Addendum No. 2

Date: Dec. 12, 2022

Project: Longview School District
Bus Garage Repair
Project Number 2022-28
Longview, WA

A201

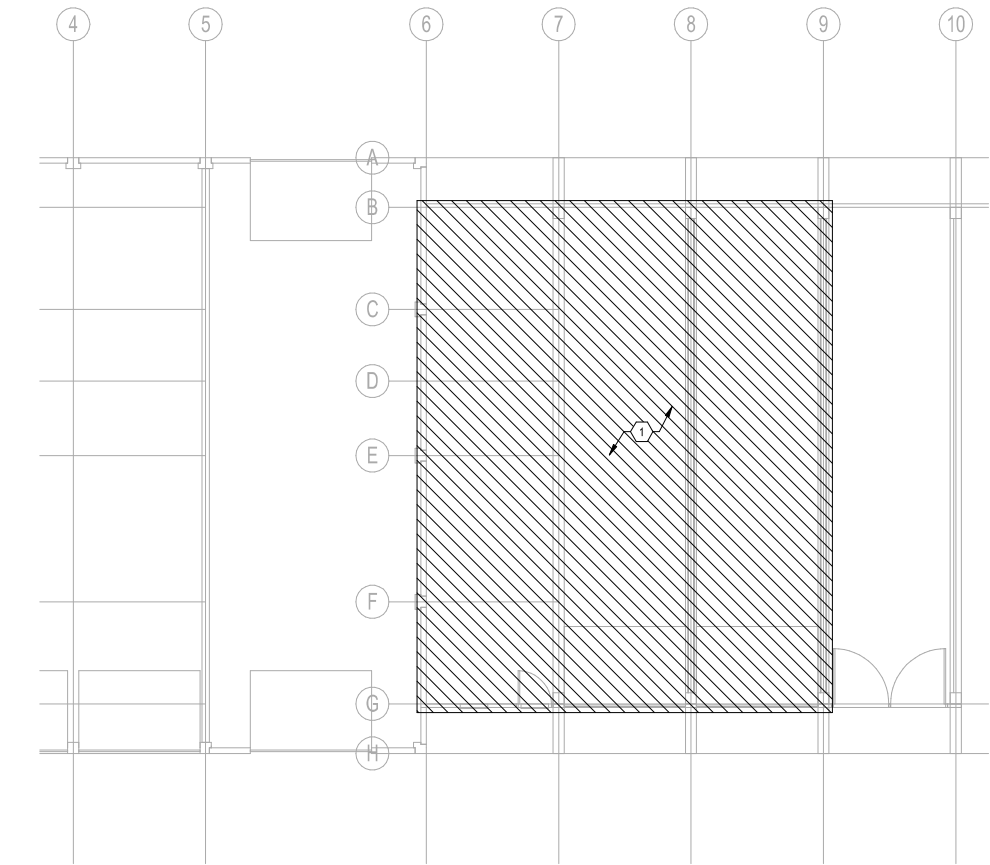
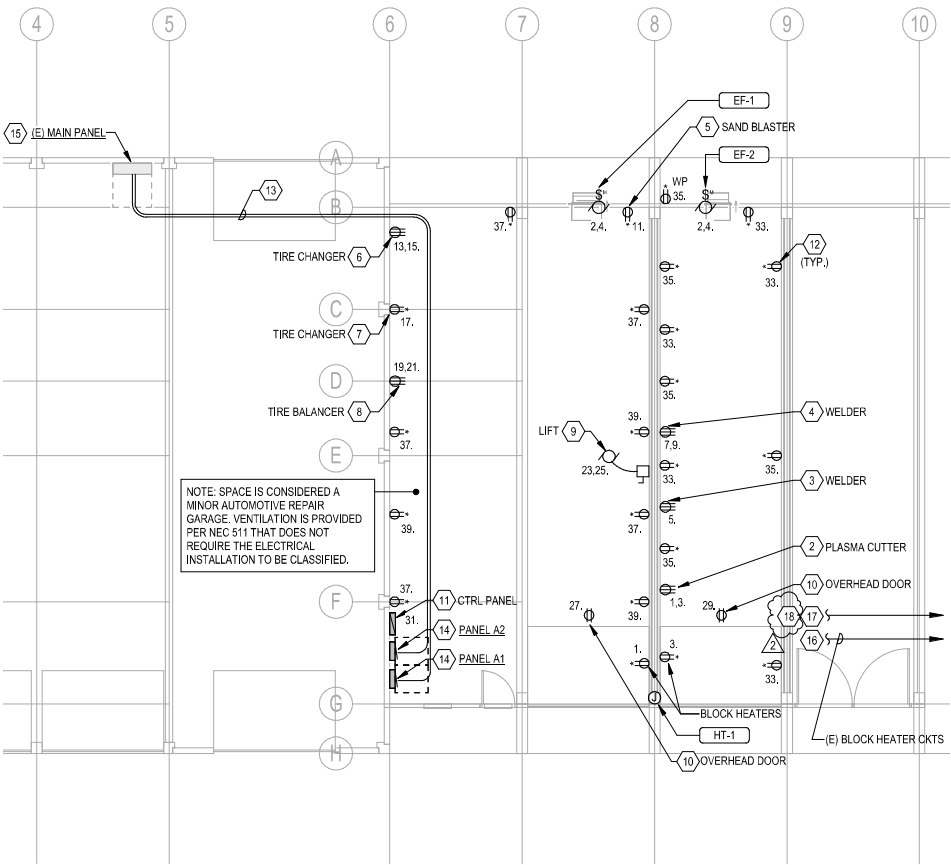
Item #	Location/Section:	Description
2.01	RFI A201	Keynote numbers do not correlate, corrected misaligned Keynotes see revised Floor Plan 2/ A201

E501

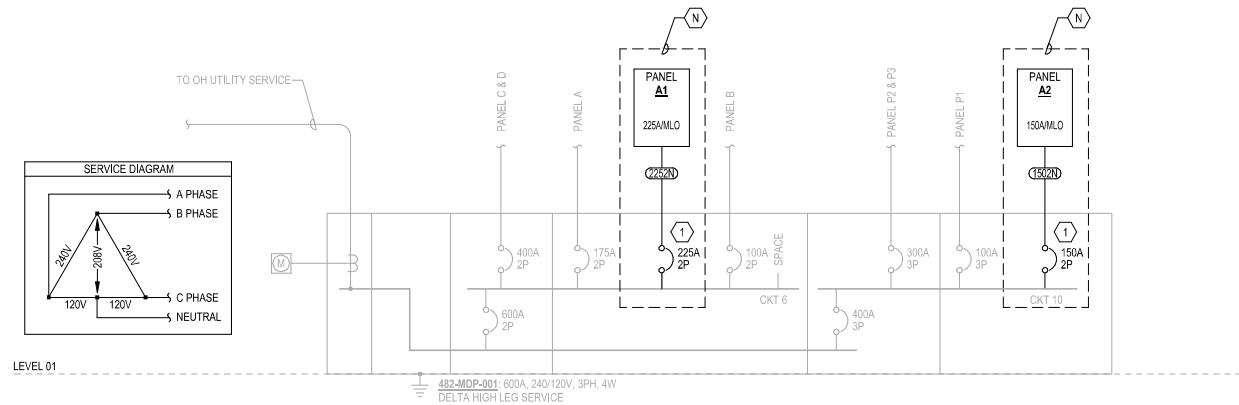
Item #:	Sheet/Detail:	Description:
2.02	Electrical E201	Updated keynote for gate circuit
2.03	Electrical E501	Load Calculations Provided

RECORDED PEAK DEMAND: 91.7 KVA
NEC 220.87 ADJUSTMENT FACTOR (125%): 114.6 KVA
NEW CALCULATED LOAD ADDED: 72.6 KVA
TOTAL CALCULATED LOAD (KVA): 187.2 KVA
TOTAL CALCULATED LOAD (AMPS): 451.2 AMPS

NOTES:
-BASED ON 30-DAY DEMAND READING.
-SERVICE VOLTAGE IS 240V/3PH DELTA.
